SITE PLAN & ARCHITECTURAL COMMISSION AGENDA OCTOBER 19, 2018

IN THE MATTER OF SITE PLAN AND ARCHITECTURAL COMMISSION)
FILE AC-18-094 APPLICATION FOR PROJECT REVIEW SUBMITTED) **ORDER**
BY STYLUS DEVELOPMENT LLC)

REVISED STAFF REPORT

Consideration of plans for the development of a 32-unit, three-story apartment building on approximately 1.1 acres located on the south side of East Barnett Road, approximately 600 feet east of Ellendale Drive within the MFR-30 (Multiple Family Residential – 20 to 30 dwelling units per gross acre) zoning district (371W32AB500).

CITY OF MEDFORD
EXHIBIT # _____
File # ZC-18-008

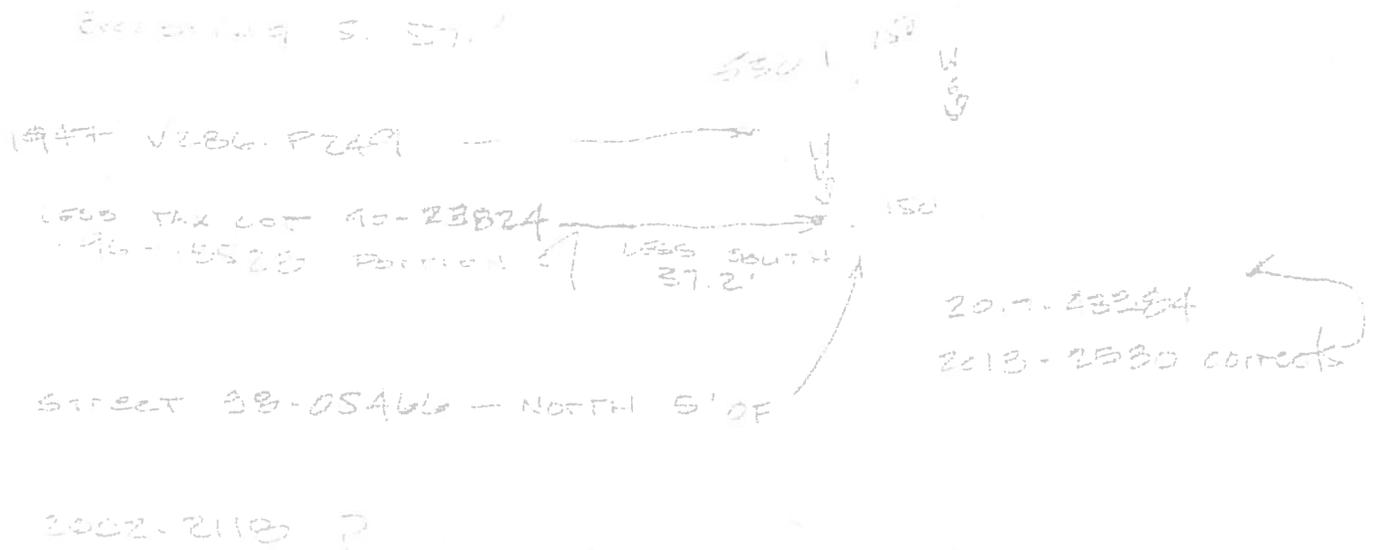
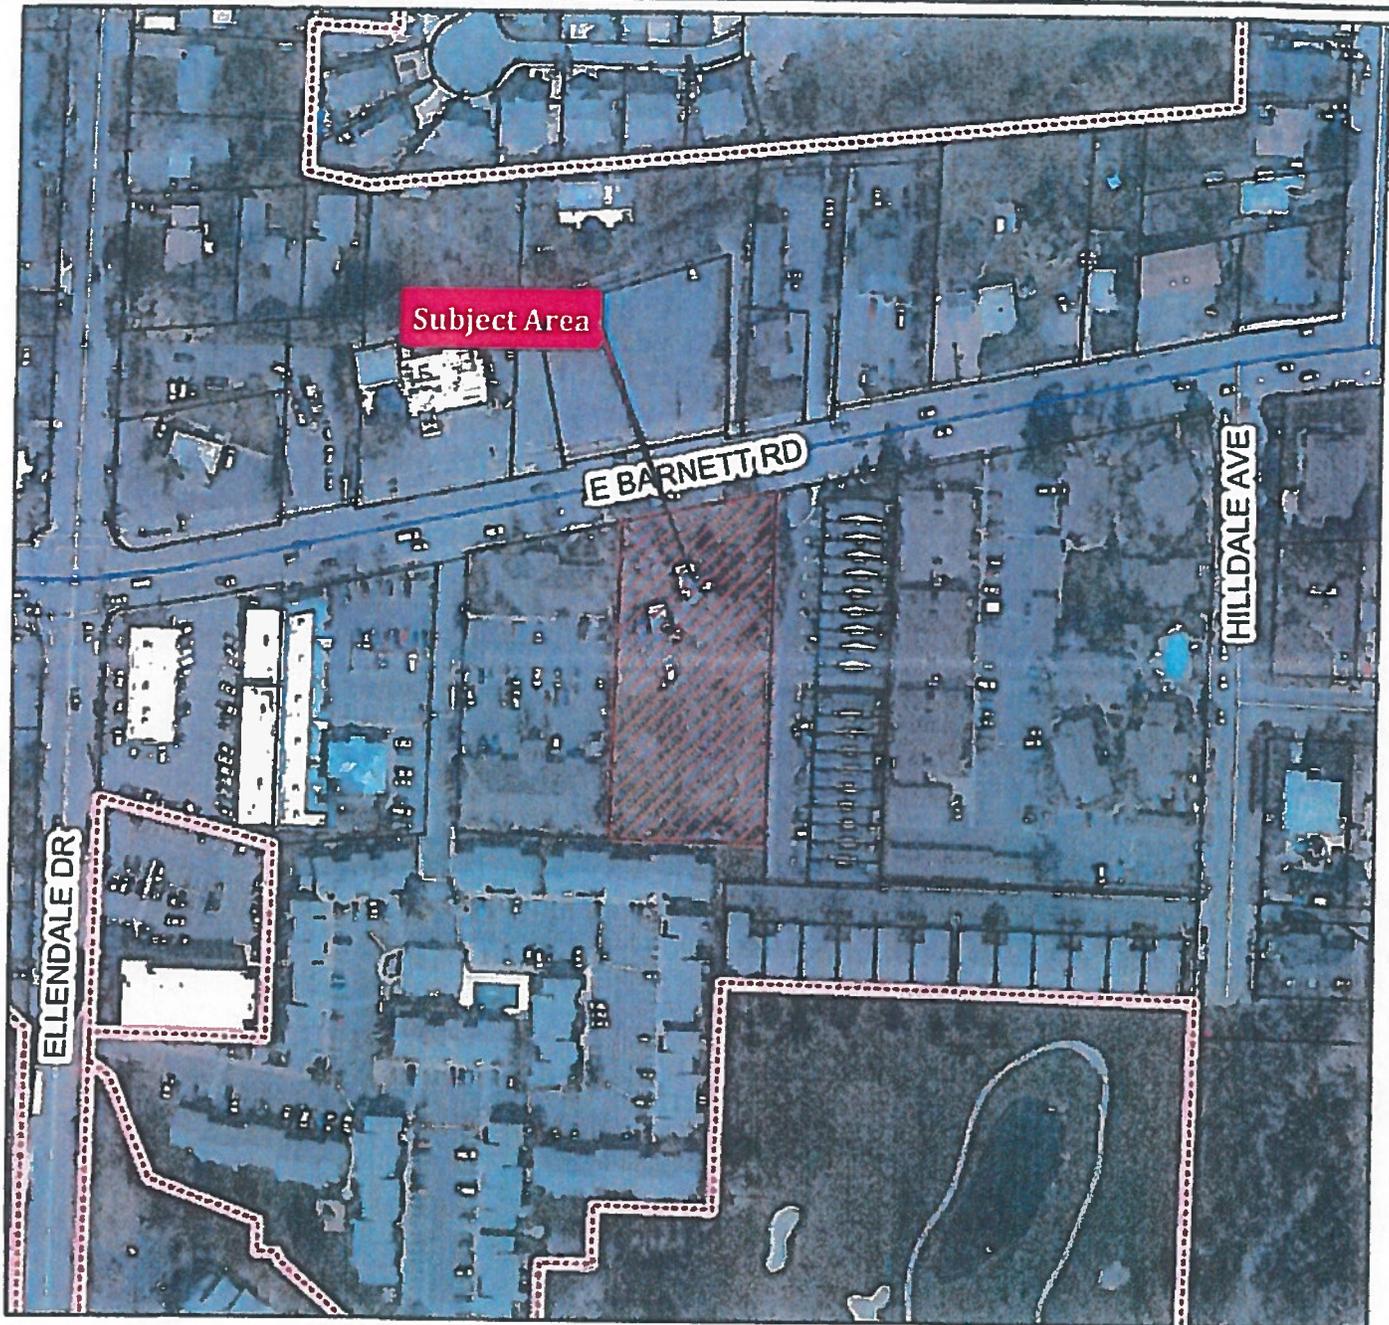
Please verify the attached legal description covering the below subject at your earliest convenience. See attached map.

Planning might consider the need for "Validation" per ORS 92.176 if unit of land was unlawfully established(?)

Subject: AC-18-094 Legal Description review

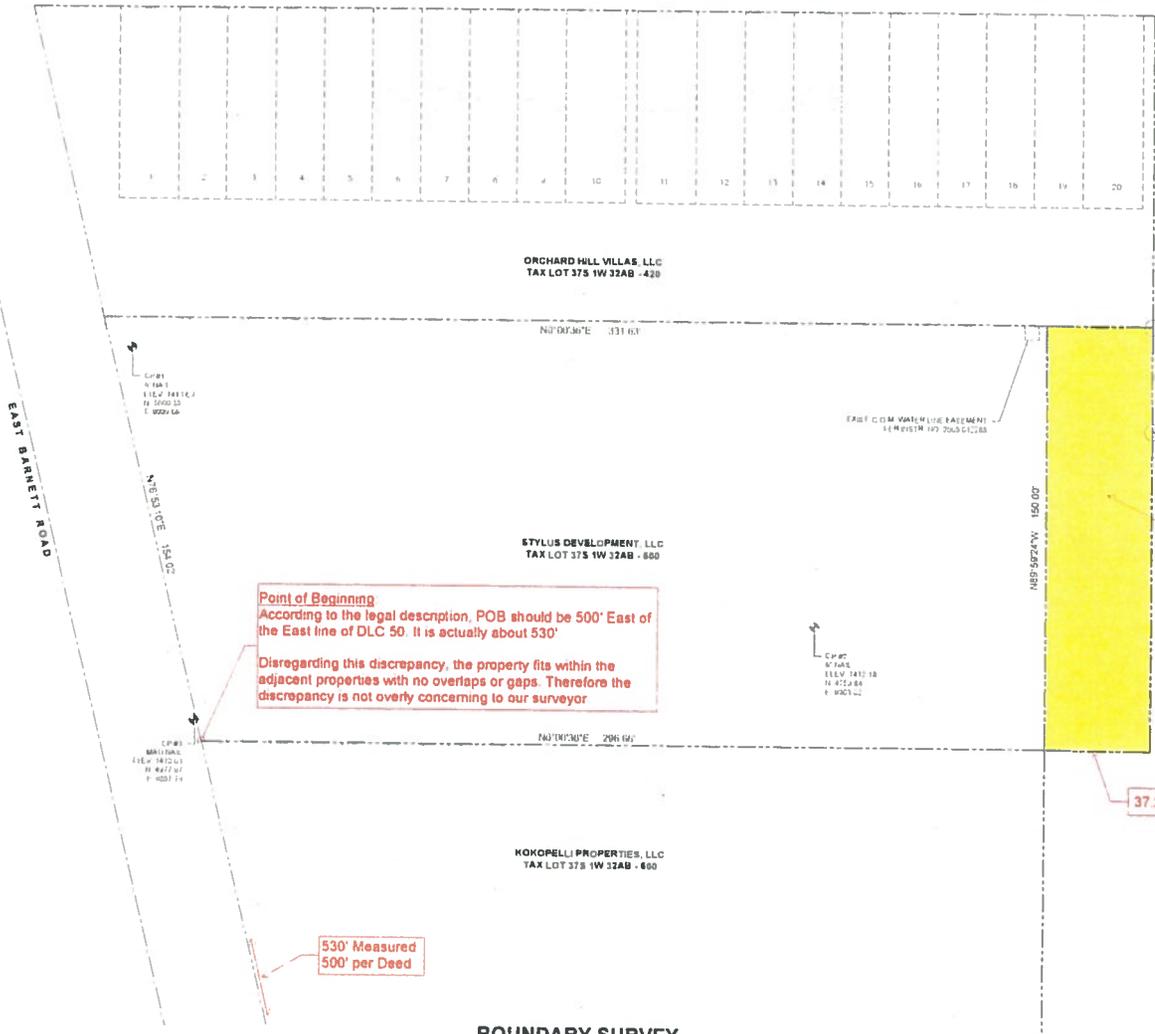
Please find the attached review of the legal description for AC-18-094.
